KWM-380 TRANSCEIVER (622-5093-101)  
HF-380 TRANSCEIVER (622-3580-101)  
RECEIVER-EXCITER CIRCUIT CARD A3 (638-6908-001)

SERVICE BULLETIN NO 1

PRODUCT IMPROVEMENT

P/O Synthesizer Variable Reference Frequency Loop A5A2  
Figure 1

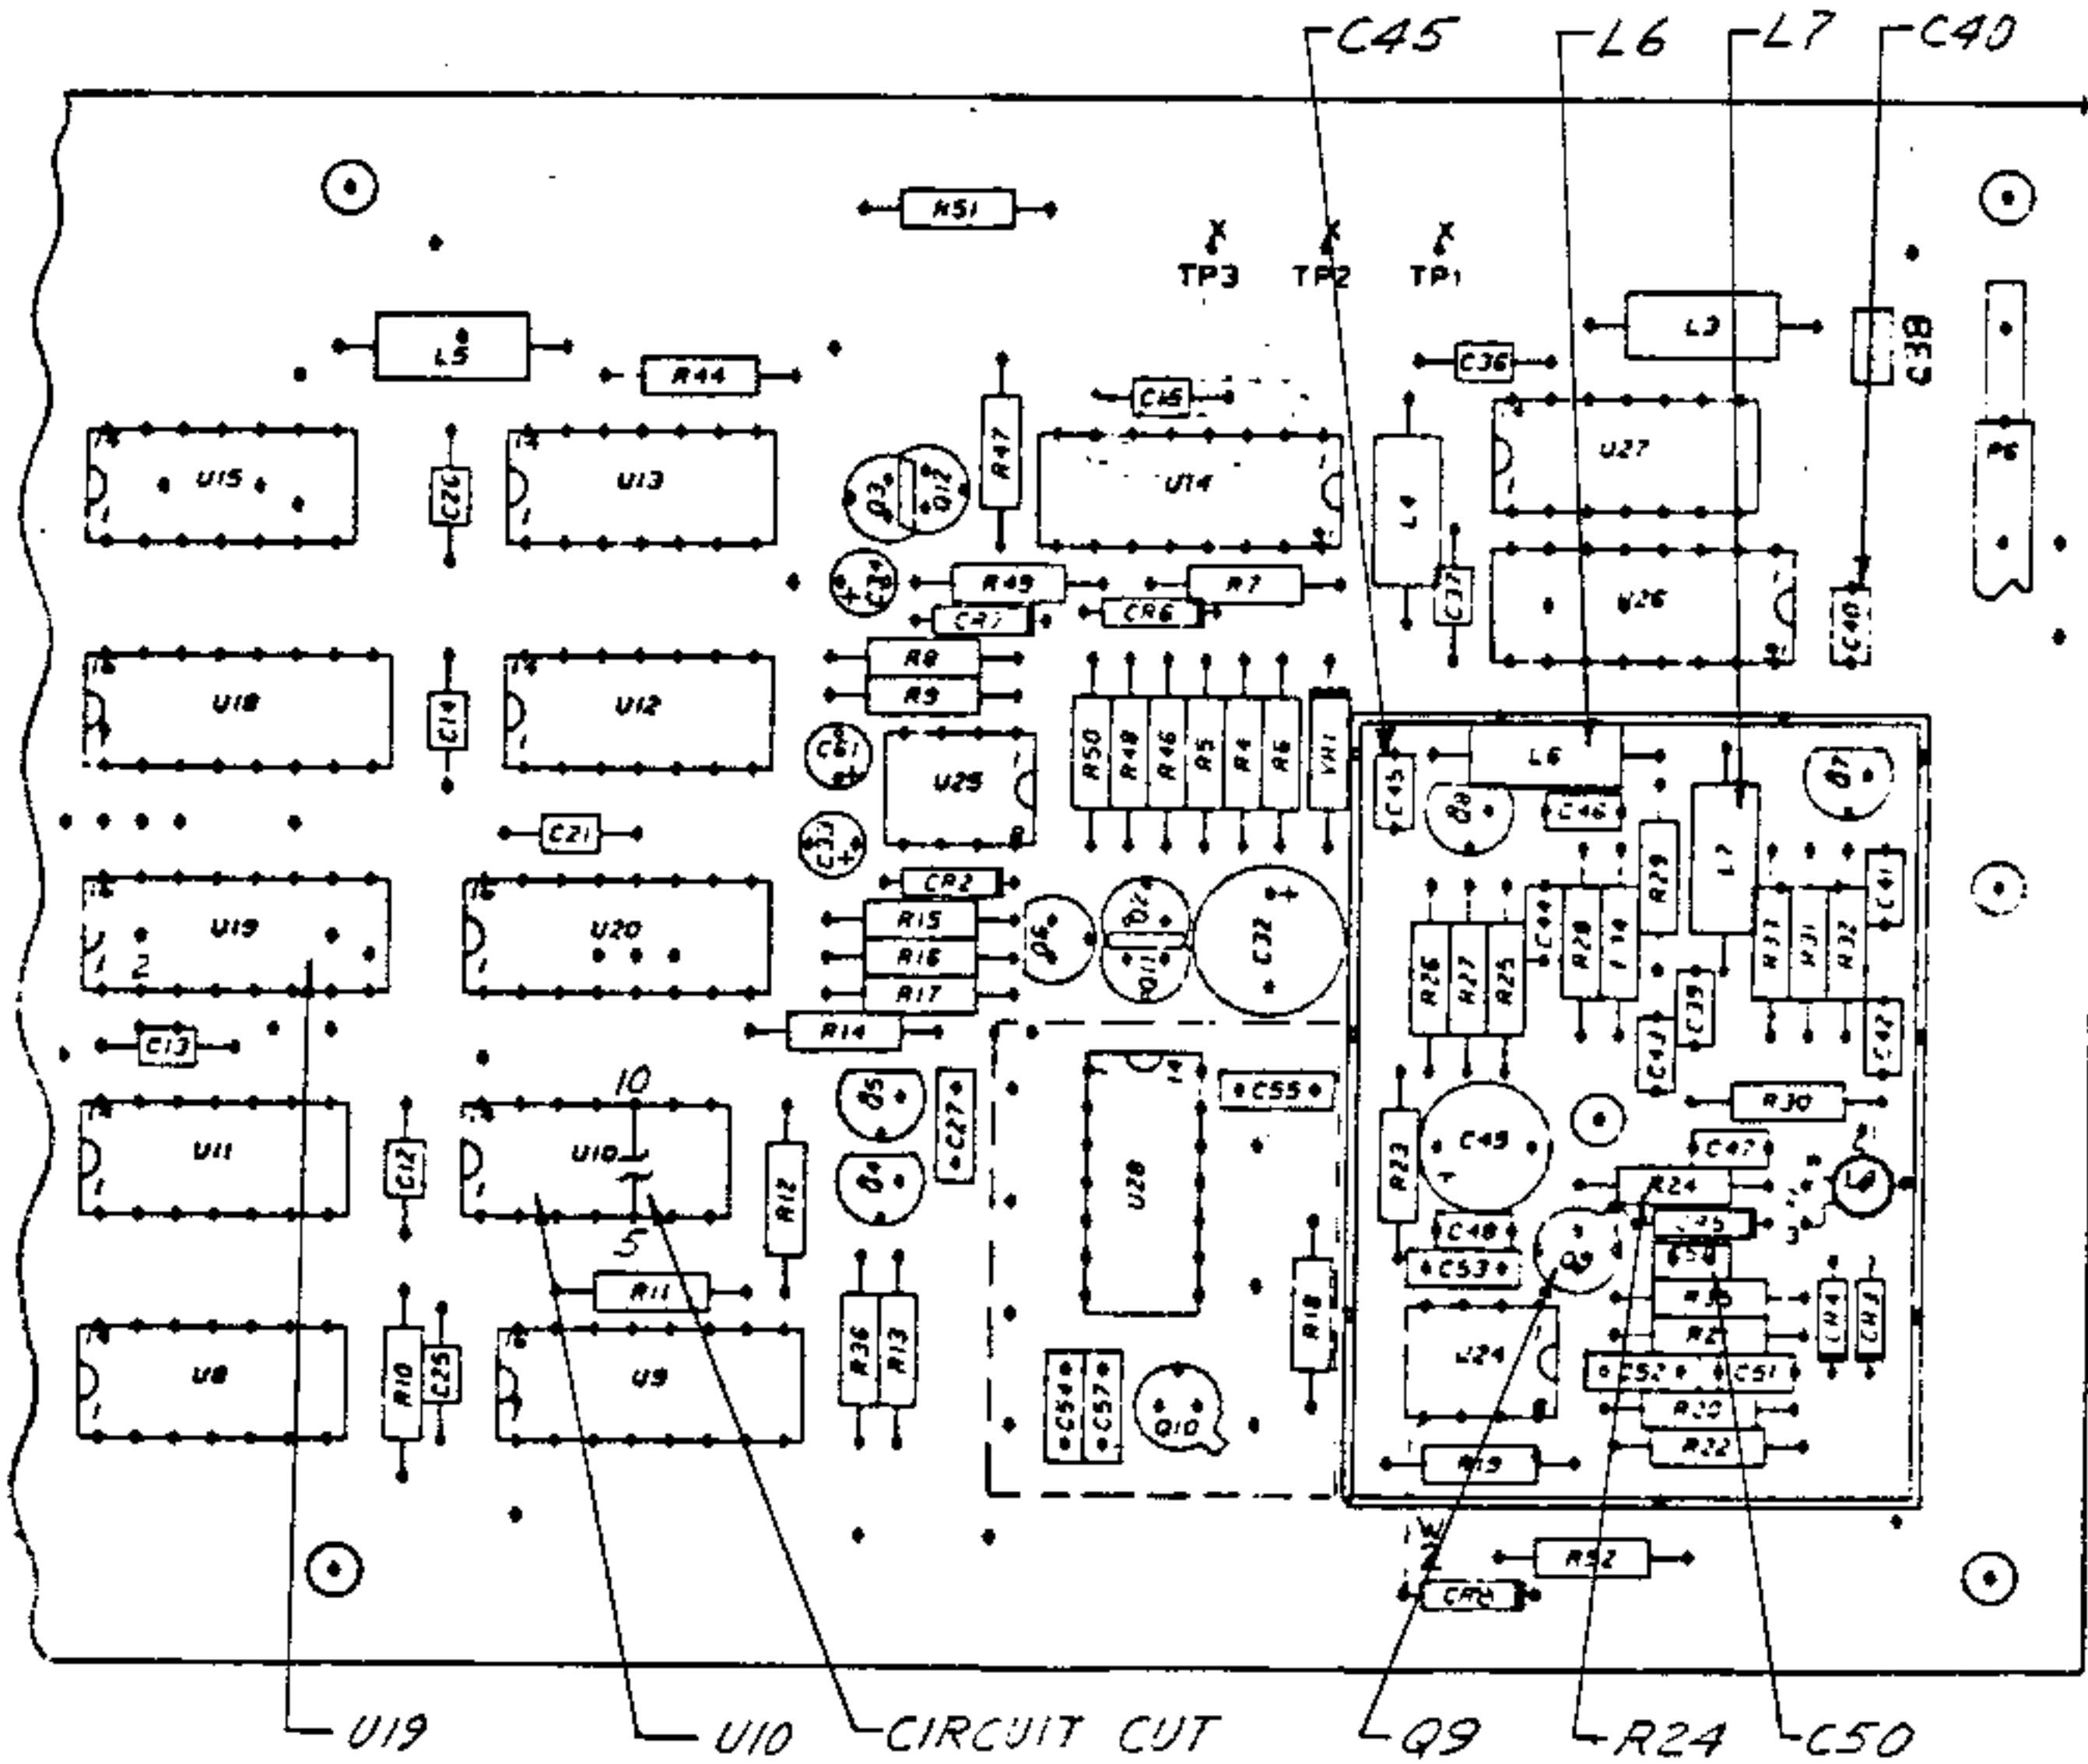
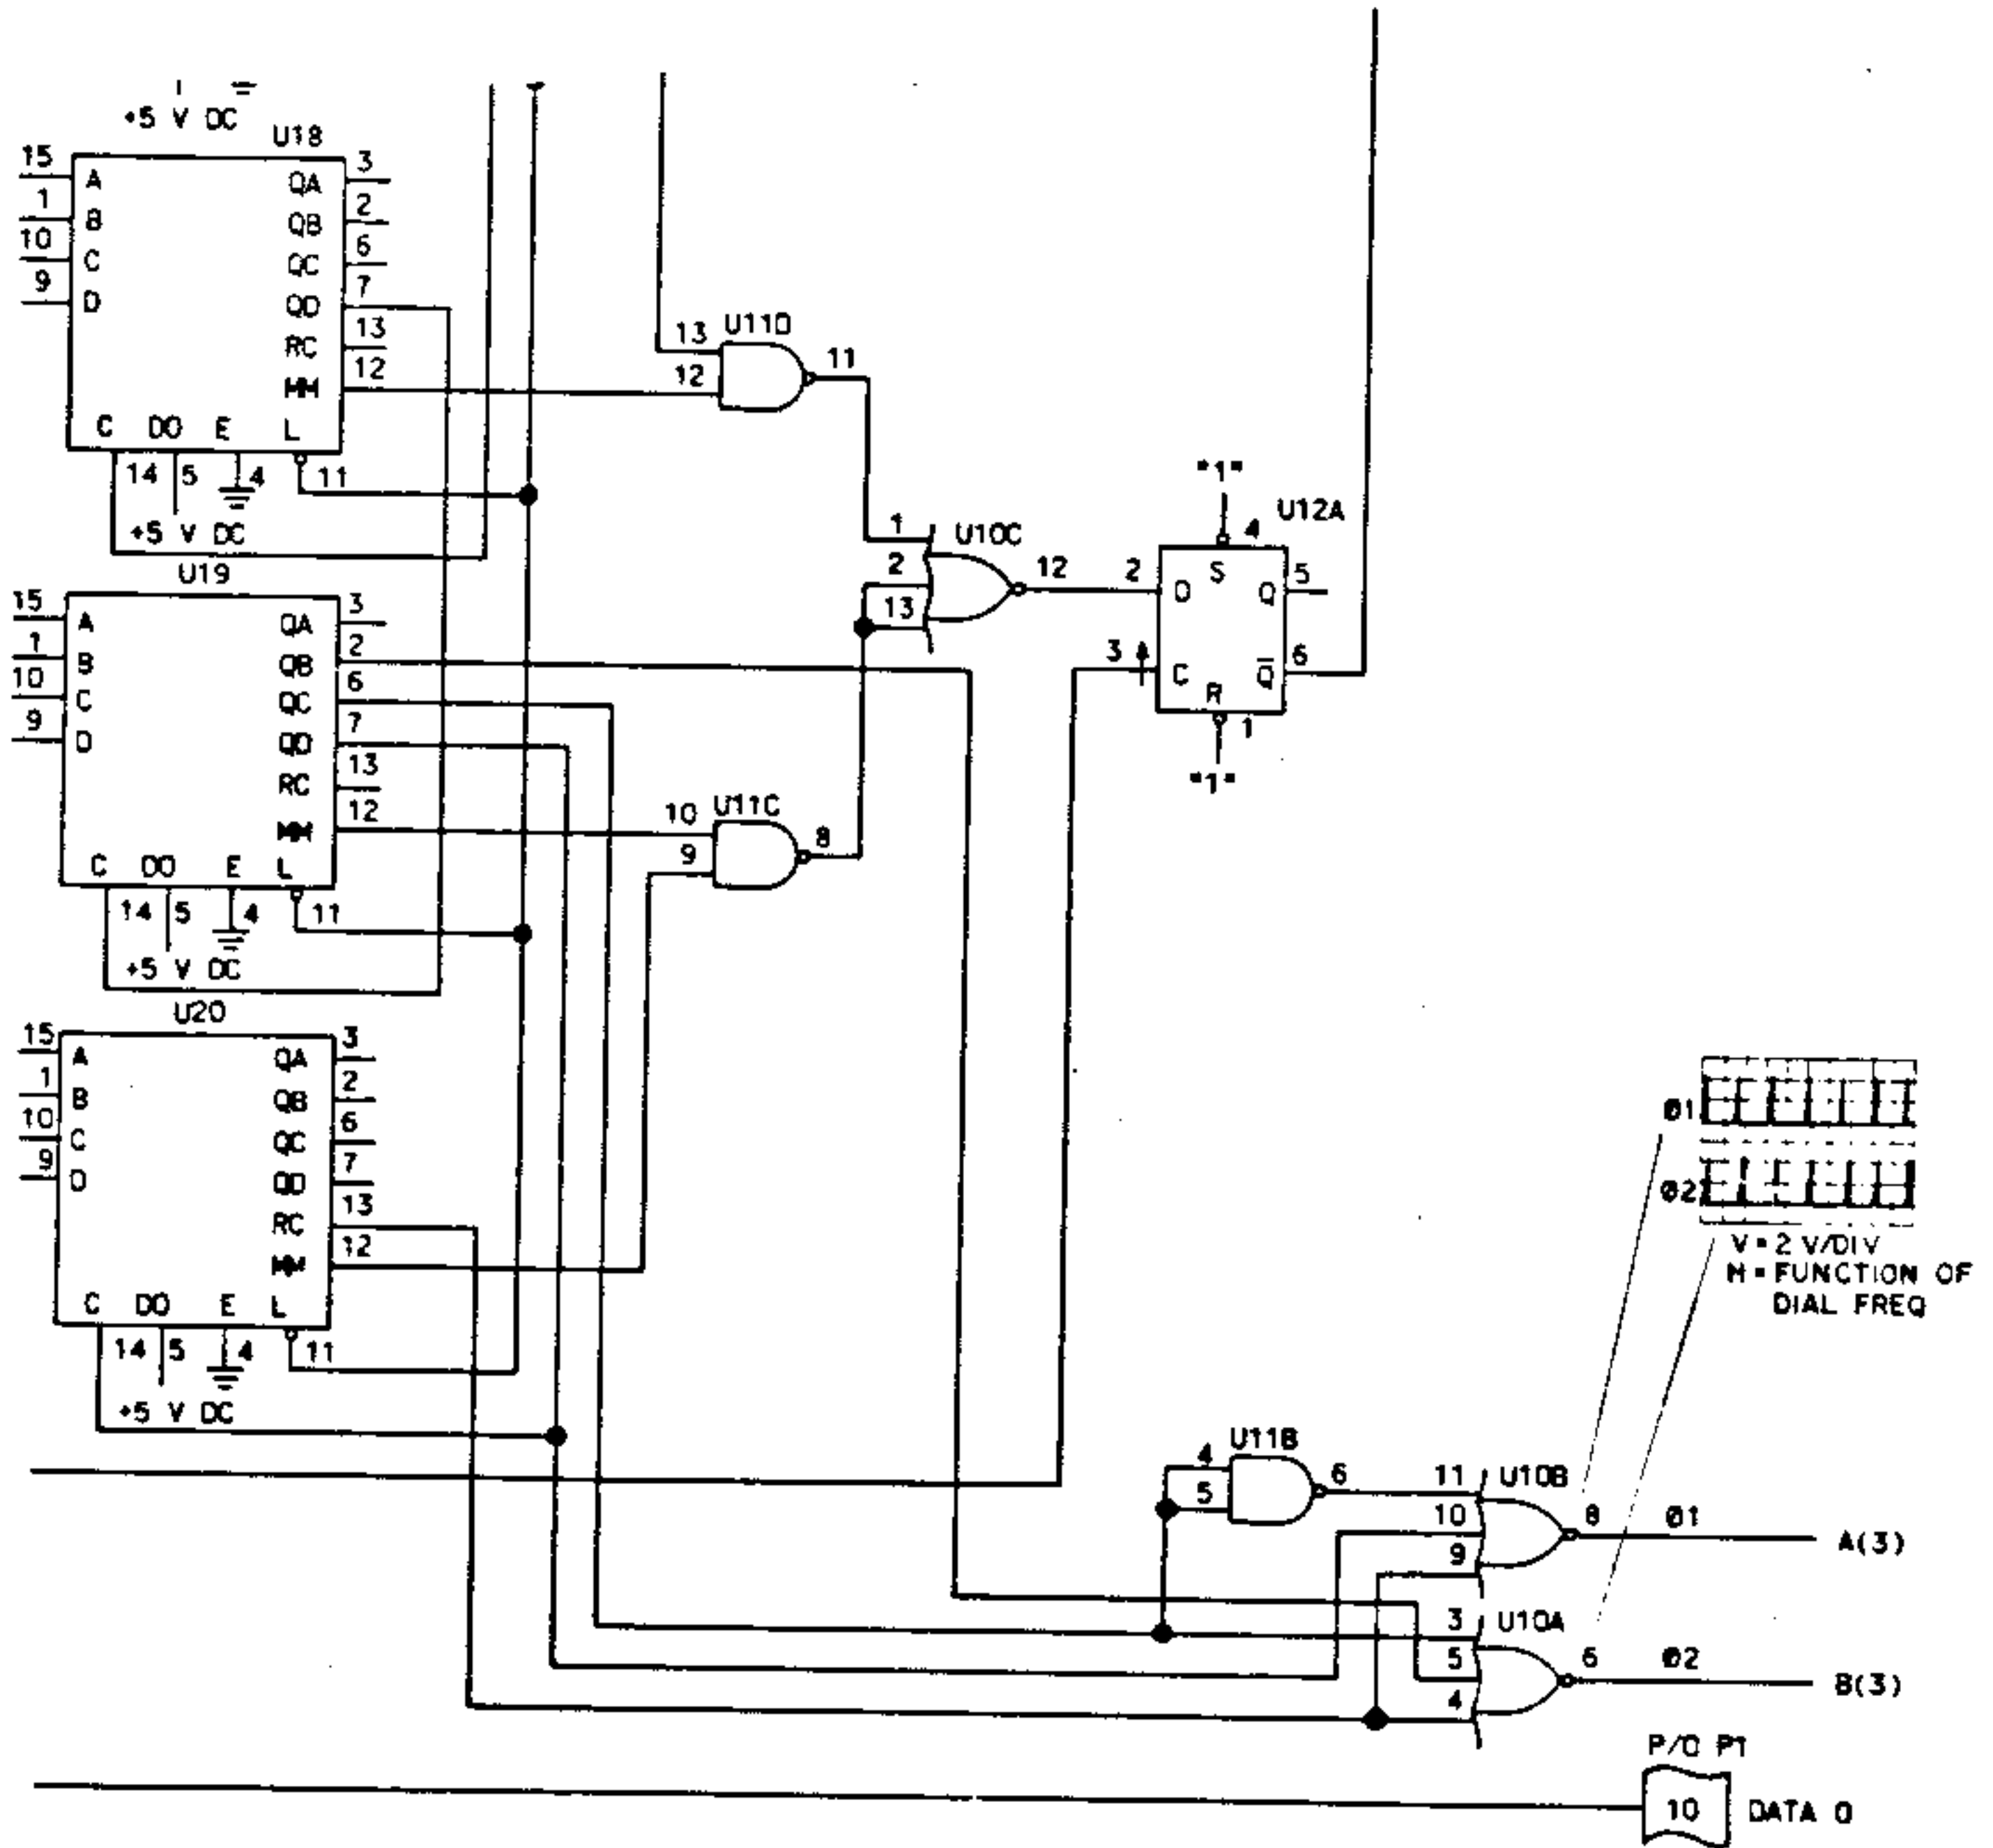
**NOTE:** Refer to figure 1 for location of components. Refer to figure 2 for a schematic diagram showing the revised U10/U19 connections.
